# City of Alachua

## Planning & Community Development Department Staff Report

August 11, 2020

<b>SUBJECT:</b>	A request for a Site Plan to construct a ±3,349 square foot quick service restaurant with associated parking, stormwater, landscaping, and site improvements
<b>APPLICANT/AGENT:</b>	Robin Kendall, Quality Dining, Inc.
<b>PROPERTY OWNER:</b>	T&H Property Group, LLC
<b>LOCATION:</b>	16130 NW US Highway 441
<b>PARCEL ID NUMBERS:</b>	03061-004-001
<b>FLUM DESIGNATION:</b>	Commercial
<b>ZONING:</b>	Commercial Intensive (CI)
<b>OVERLAY:</b>	US 441/I-75 Gateway Overlay District
<b>ACREAGE:</b>	±1.19 acres
<b>PROJECT PLANNER:</b>	Justin Tabor, AICP
<b>RECOMMENDATION:</b>	Staff recommends that the Planning & Zoning Board approve the Site Plan for quick service restaurant at 16130 NW US Highway 441, subject to the three (3) conditions provided in Exhibit "A" and located on page 21 of the August 11, 2020 Staff Report to the Planning & Zoning Board.
<b>RECOMMENDED MOTION:</b>	<i>Based upon the competent substantial evidence presented at this hearing, the presentation before this Board, and Staff's recommendation, this Board finds the application to be consistent with the City of Alac

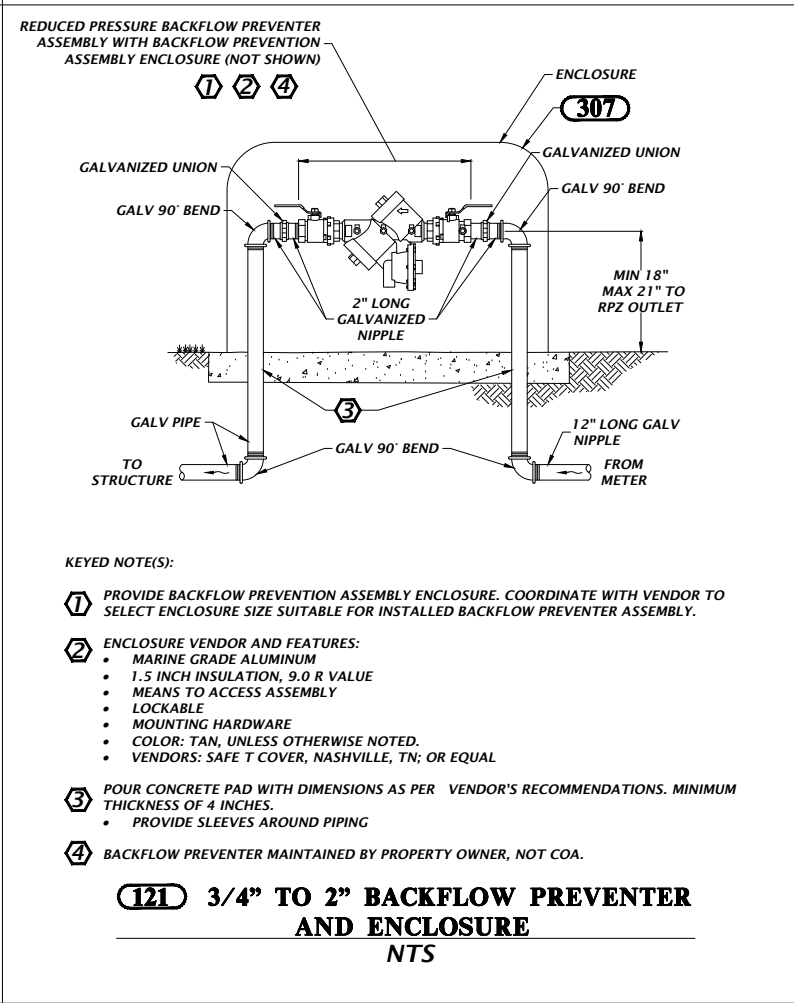
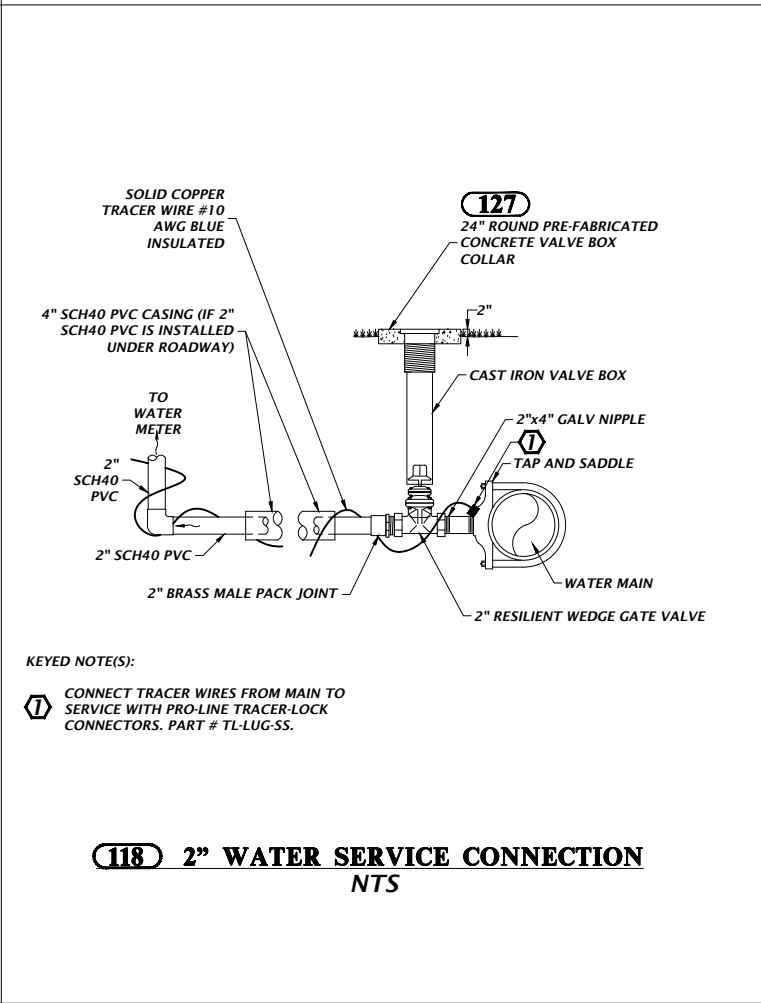
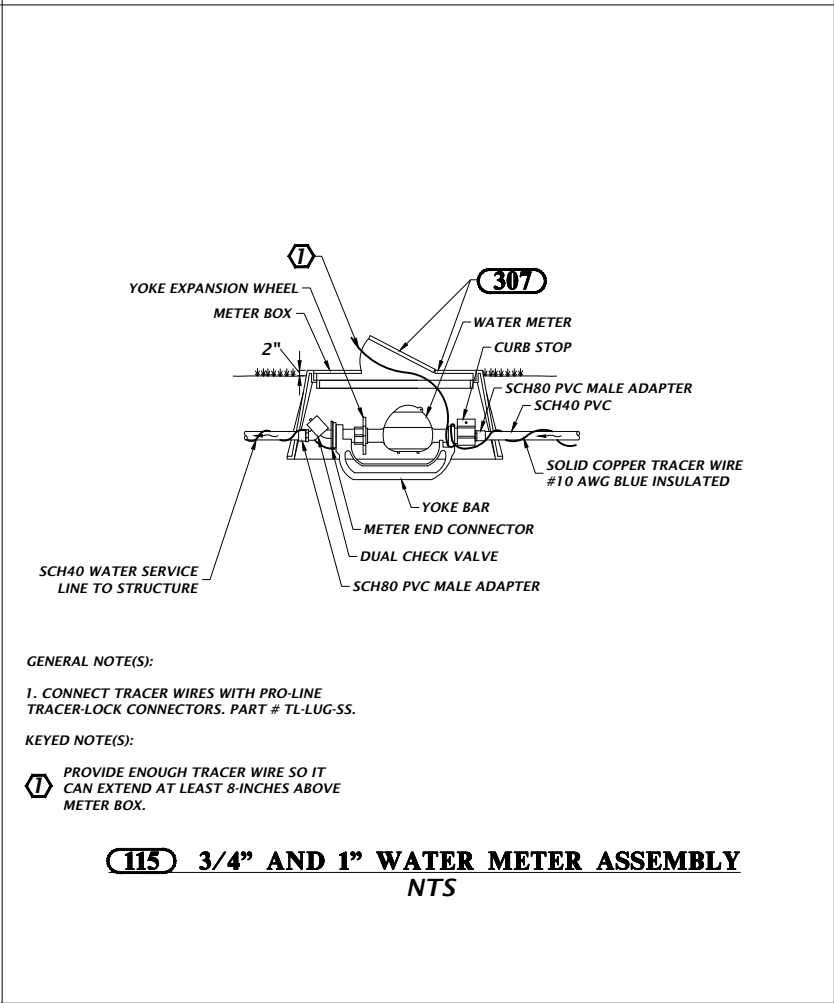
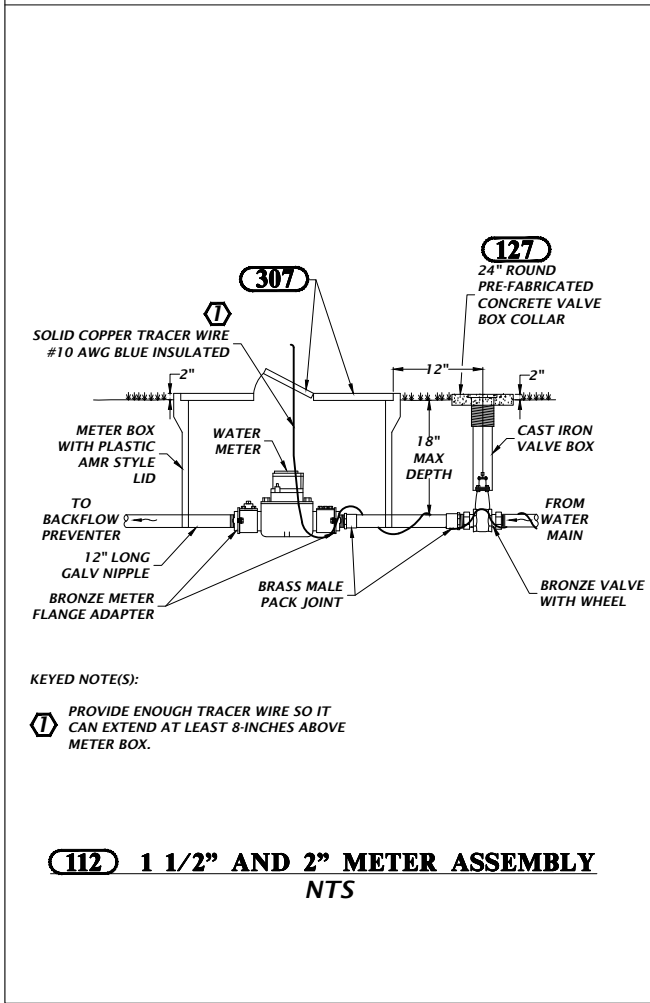
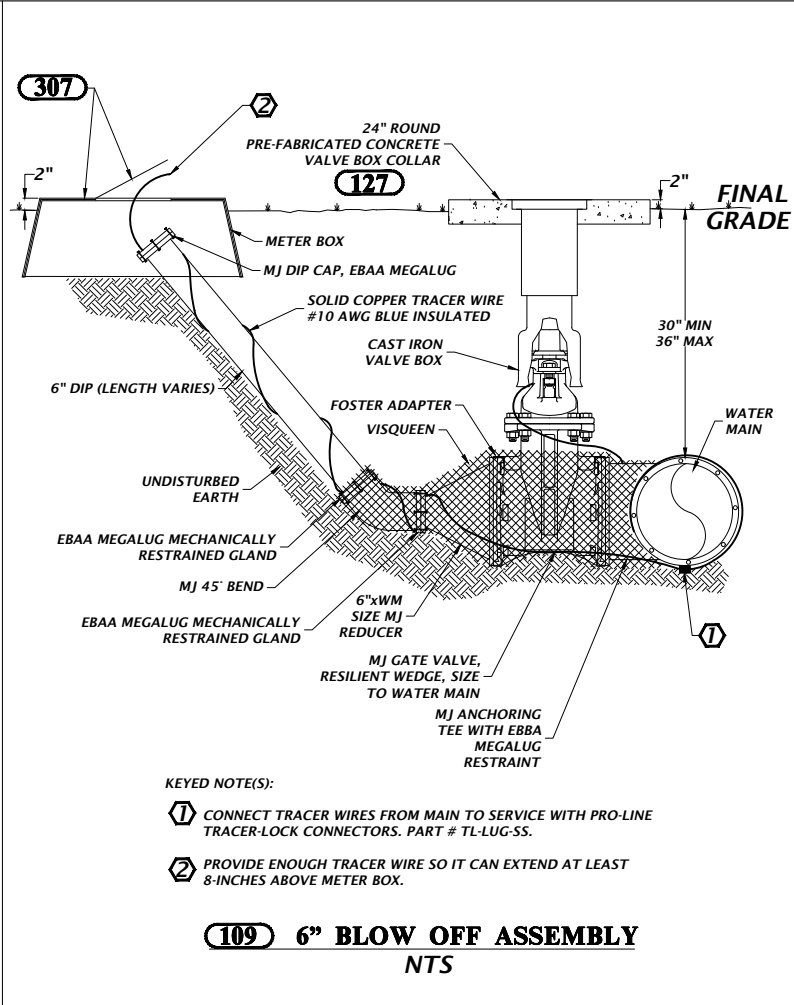
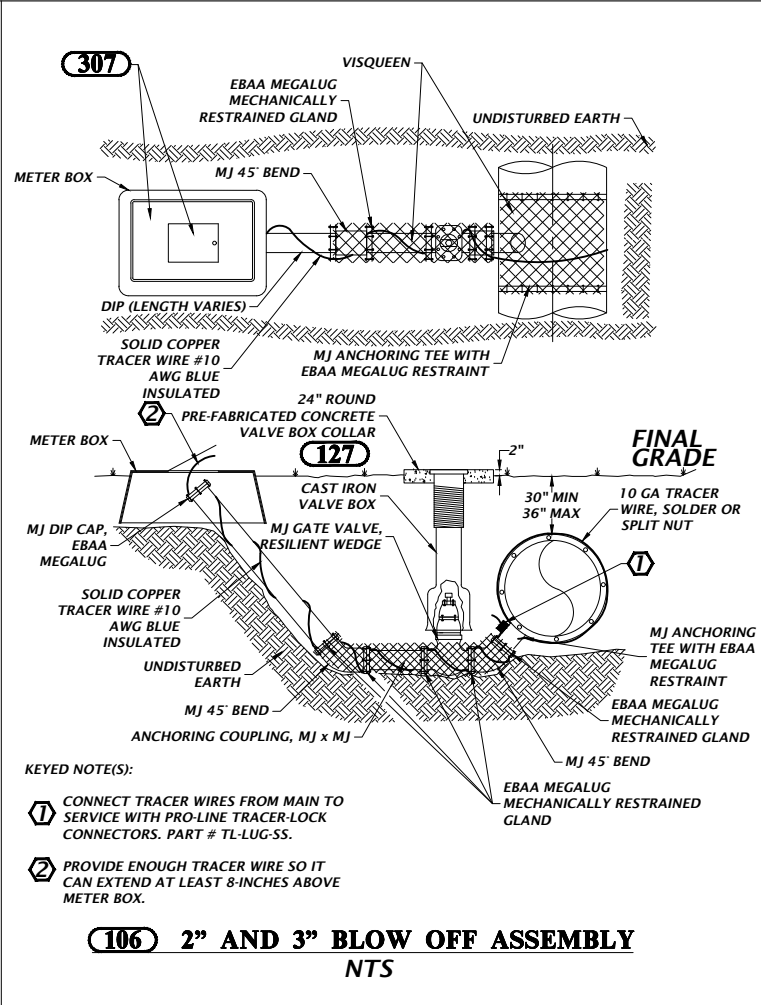
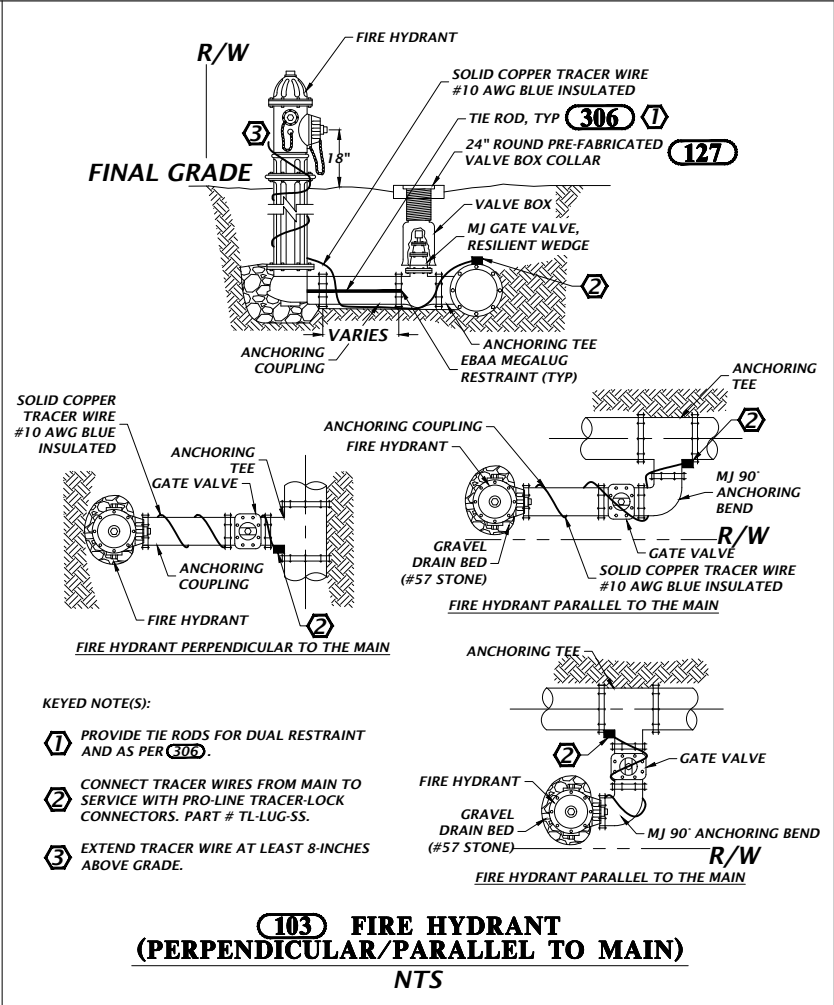
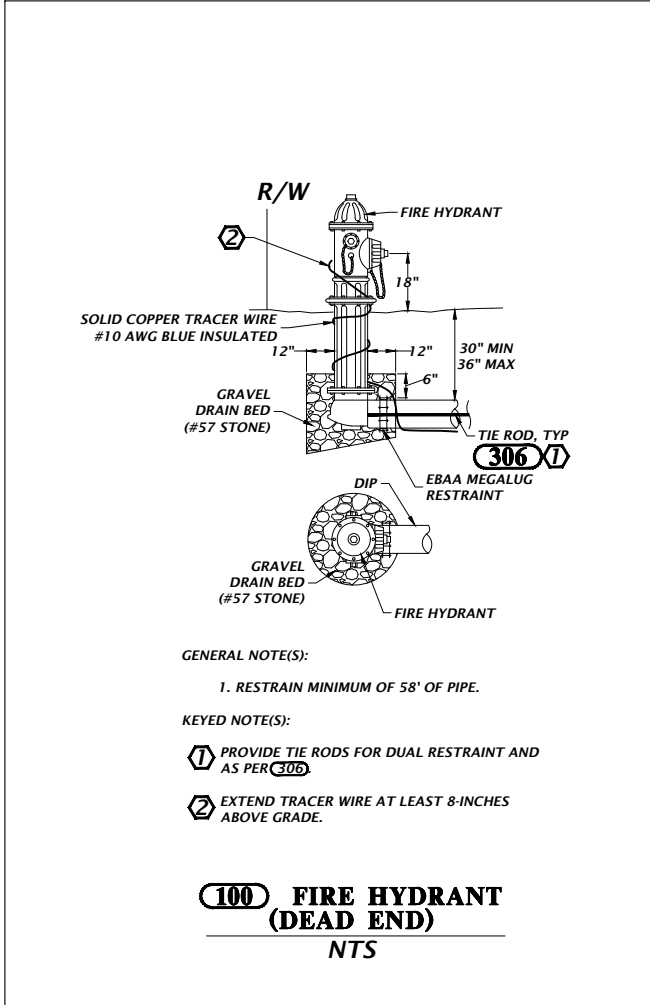
NO.	COMMENTS
1.	<p><b>Comment on Jan 12th Submittal</b></p> <p><b>Sheet C02:</b></p> <p>Minor Comment, Referenced Specifications: Please change Note 4 to "City of Alachua, Department of Public Services, Design and Construction Manual, Public Utilities, 2020".</p> <p>Minor Comment, General Note 11: Please replace "City of Alachua Water &amp; Sewer District" with "City of Alachua Public Services Department".</p> <p>Please add the following note: "XX. Electric service provided by the City of Alachua".</p>

2.	<p><b>Comment on Jan 12th Submittal</b></p> <p><b>Sheet C04:</b></p> <ul style="list-style-type: none"><li>On the lower right of property is a fenced (8-foot high PVC fence) area. What is its purpose? Other than the gate facing the road, does it need another gate so it can be accessed from the Burger King building?</li><li>The gate is shown as the "swing-out" type. Please change to a "swing-in" type so it</li></ul>

NO.	COMMENTS
	reduces staff-traffic interface.
3.	<p><b>Comment on Jan 12th Submittal</b></p> <p><b>Sheet C05A:</b> To enhance clarity, suggest changing the pavement legend text to:</p> <ul style="list-style-type: none"> <li>• “Standard Duty Asphalt (See U.S. 441 Driveway Pavement Detail)”</li> <li>• “U.S. 441 Shoulder Asphalt (See Shoulder Pavement Detail)”</li> </ul>

4.	<p><b>Comment on Jan 12th Submittal</b></p> <ul style="list-style-type: none"> <li>• Sheet C06, Note 4: Please review meaning of “conveyed”? Should it instead be “connected”?</li> <li>• Sheet C06, General Utility Note 9: Please add “electric service”.</li> <li>• Sheet C06, Please add the following general note: “In the right-of-way, to both the 2-inch water line and 6-inch gravity sewer main, install 2-pair, 10- gauge tracer wire with enough unwrapped wire to allow connection to test device.”</li> </ul>

5.	<p><b>Comment on Jan 12th Submittal</b></p> <ul style="list-style-type: none"> <li>• Sheet C06, Electrical: The electric service will not be provided from the overhead line and power pole. Instead show a pad-mounted transformer close to where the power pole is. Also, show a new underground electric line from the Utility Box to the pad-mounted transformer.</li> <li>• Sheet C05, Electrical: Please add the following General Utility Note: “The City of Alachua will procure and install the pad- mounted transformer, the pad and also the conduit &amp; conductors from the utility box to the pad-mounted transformer. This work shall be done at no cost to the City, who will backcharge the Contractor. All electric work “downstream” the transformer shall be the responsibility of the Contractor”.</li> </ul>

6.	<p><b>Comment on Jan 12th Submittal</b></p> <ul style="list-style-type: none"> <li>• Sheet C06, Electrical, The City of Alachua will provide 277/460 Volt 3-phase electrical power at the transformer. Please confirm that this is acceptable. Other power types may be available.</li> <li>• Sheet C06: Please provide a load schedule so that the City can size the transformer. When will the load schedule be available?</li> </ul>

7.	<p><b>Comment on Jan 12th Submittal</b></p> <ul style="list-style-type: none"> <li>• <b>Sheet C06, Cleanout:</b> A cleanout is shown within the property line in the lower left. Please either:</li> <li>• Relocate the cleanout so it is in the right-of-way, or:</li> <li>• Keep as is, but add a second cleanout in the right of way, or.</li> <li>• Keep as is, but grant an easement to access the cleanout.</li> </ul>

NO.	COMMENTS
8.	<p><b>Comment on Jan 12th Submittal</b></p> <ul style="list-style-type: none"> <li>Sheet C06: Where the new 2-inch water line connects to the existing 16-inch DIP, a corporation stop is called out. As per CoA standards, please replace with a 2-inch resilient seat gate valve with valve box.</li> </ul>

9.	<p><b>Comment on Jan 12th Submittal</b></p> <ul style="list-style-type: none"> <li>Sheet C06: A dashed line is shown about 10 feet within the property line. What does it represent? Please show on legend sheet.</li> </ul>

10.	<p><b>Comment on Jan 12th Submittal</b></p> <ul style="list-style-type: none"> <li>Sheet C06: Minor Comment: A rectangular symbol has been called out as a "Power Transformer". This is on the lower left near the "OHW" &amp; "PP". This is actually a "SWITCHGEAR". Please change text.</li> </ul>

11.	<p><b>Comment on Jan 12th Submittal</b></p> <p><b>Sheet C06:</b> There is an existing underground electric line (UEL) that is not shown on any of the submitted drawings. Please address the following issues:</p> <ul style="list-style-type: none"> <li>Attached is Figure 1, which is a GIS output. Black is the property line. Red is an overhead electric line that has either has already been demolished or will soon be demolished. The dashed blue line shows an existing UEL, portions of which either coincide with or are very close to the west property line.</li> <li>Please verify that construction of the stormwater basin does not interfere with the UEL. The basin outline is at 80 ft. EL and is east of the UEL. But there appears to be some earthwork required west of the basin that may impact the underground electric line. Note that the underground electric line must have at least 4-feet of cover.</li> <li>There is a C-Inlet near the NW corner of the stormwater basin. If this C-Inlet impacts the UEL, please relocate.</li> <li>Landscaping sheet L-1 shows that trees will be planted near the property line (and buried underground electric line). The distance between trees and the property line/underground electric line appears to be about 7-8 ft., which coincidentally follows the old City standard of 7.5 ft. separation from underground electric utilities. The City is not insisting that the new standard of 15-feet separation be followed. However, could these trees be moved several feet to the east? Also, please verify that these trees (wax myrtle and red maple) have shallow roots.</li> <li>Based upon a preliminary review, there does not currently appear to be an easement for this UEL. Please obtain an public utility easement (PUE). The CoA notes that both the Burger King property and the parcel west of the Burger King property are owned by the same entity; namely, T&amp;H Property Group. Could the PUE be obtained for the UEL for both parcels?</li> <li>CoA suggests that this UEL be shown on the drawings. Suggested approach is to</li> </ul>

NO.	COMMENTS
	request a 811 Line Locator design ticket, which will prompt CoA staff to locate the UEL with visible marking paint and flags at grade. The developer would then instruct the surveyor to update the applicable drawings.

12.	<p><b>Comment on Jan 12th Submittal</b></p> <p>Sheet C09 shows Civil Details, which are based on CoA Standard Details, 2017 Version. Please replace with the updated 2020 standard details, as follows:</p> <ul style="list-style-type: none"> <li>• Partly because the updated 2020 standard details cross-reference other sheets, the required number of details has increased from 4 to 6. These 6 detail sheets are attached in PDF format.</li> <li>• All CoA standard details are also attached in AutoCad format, version 2014. The Engineer may prefer to use details in AutoCad, which could edited so just the details required for the project would become part of the Contract Documents.</li> </ul>
END OF COMMENTS
